N9961A-01

Modification Recommended Service Note

N9961A – 44 GHz FieldFox RF analyzer

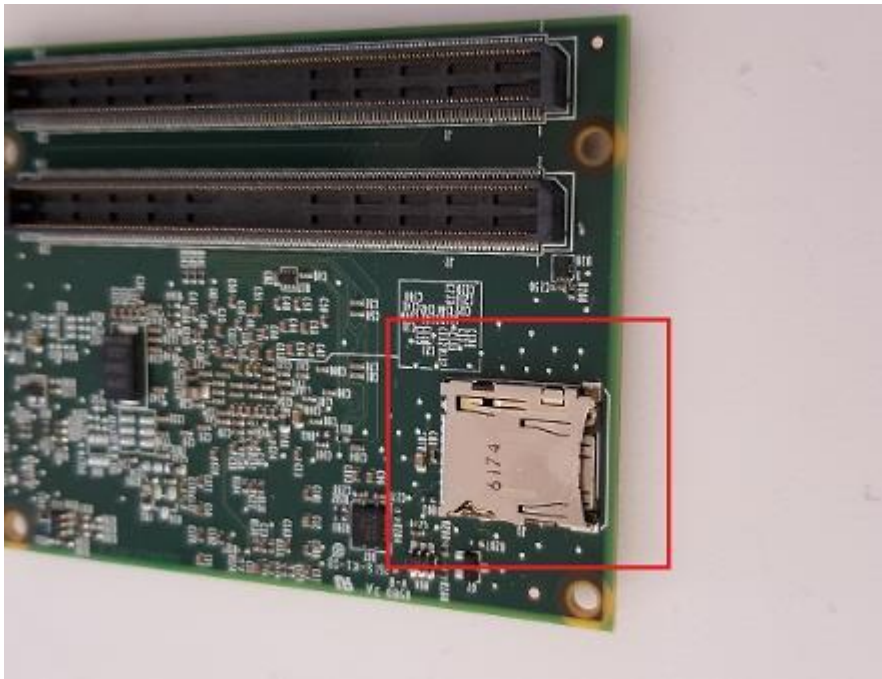
c. Using an Exacto Knife remove the Epoxy bridge holding the SD Card into the SD card socket.

d. Use caution to not damage the socket or other parts of the CPU board.

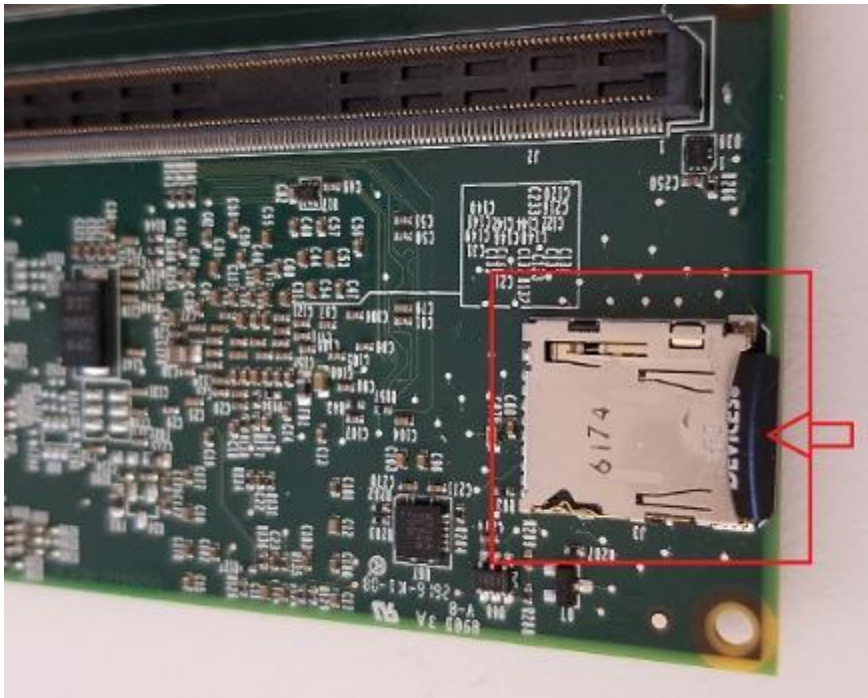
f. Here are the Old and New SD cards. The old SD card (Patriot) is on the left. The New (Delkin) is on the right.

g. Insert the NEW SD card into the SD card socket and press it in until you hear a click, then release. The SD card is now locked in the socket.

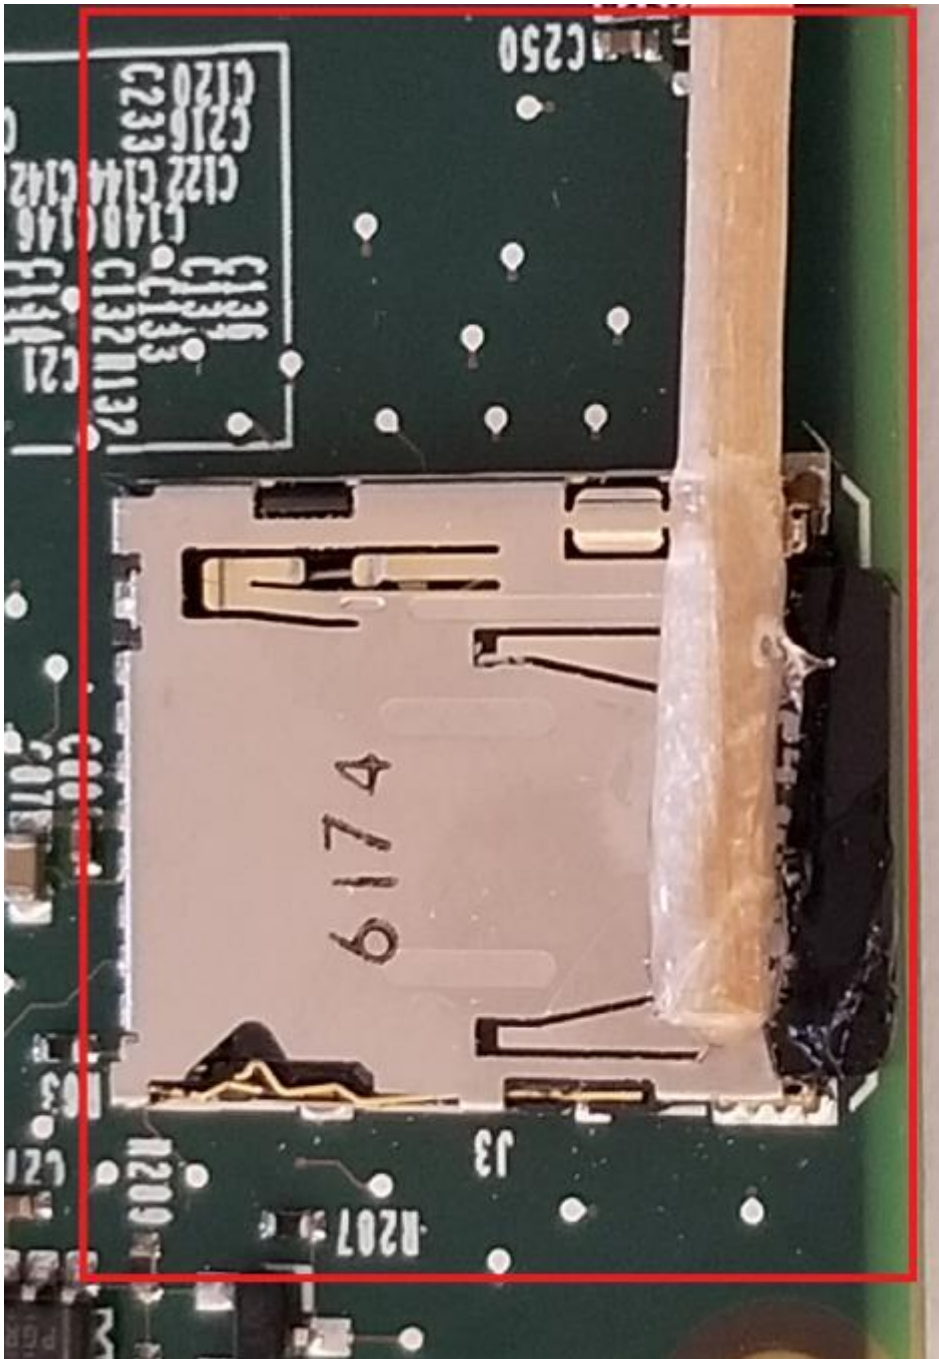
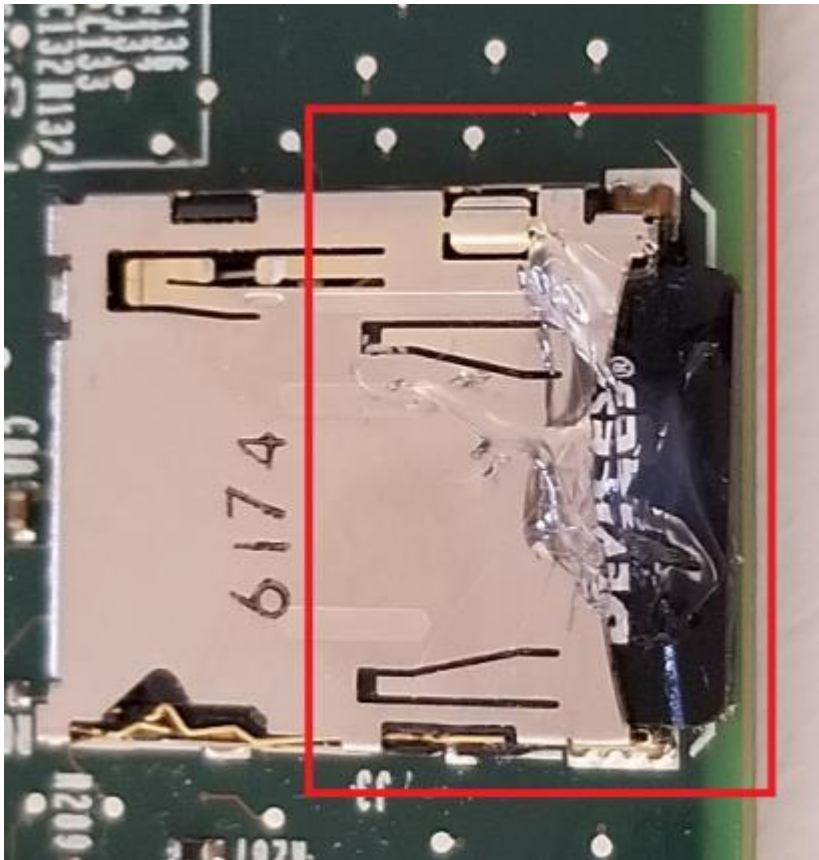
h. It is now necessary to add a small amount of RTV (part number 0470-0450) to bridge the SD card to the SD card socket. Using a wooden Q-Tip place a small amount of RTV on both the SD card and the socket.
